# UNITED STATES PATENT AND TRADEMARK OFFICE

APPLICATION NO.	FILING DATE	FIRST NAMED INVENTOR	ATTORNEY DOCKET NO.	CONFIRMATION NO.
09/998,972	10/31/2001	Christopher Rogers	DEP 0639	6510

# Office Action Summary

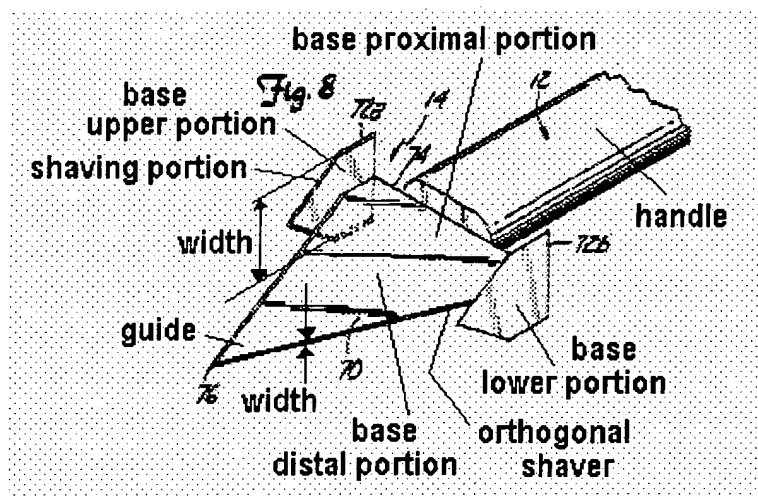
Claims 1-12, 15, 18, 22-24 and 38-44 are rejected under 35 U.S.C. 102(a) as being anticipated by Ray et al (US 5,649,945).

Note the identified structure in Ray et al Figure 8. The intent by applicant that tool be used with base upper and lower portions in a horizontal position rather than a vertical position, fails to provide for any objectively ascertainable structural distinctions between the claimed device and that disclosed by Ray et al.

In regard to claim 4, note the optional handle of Figure 9. In regard to claim 5, note the retraction means 28 (recess).
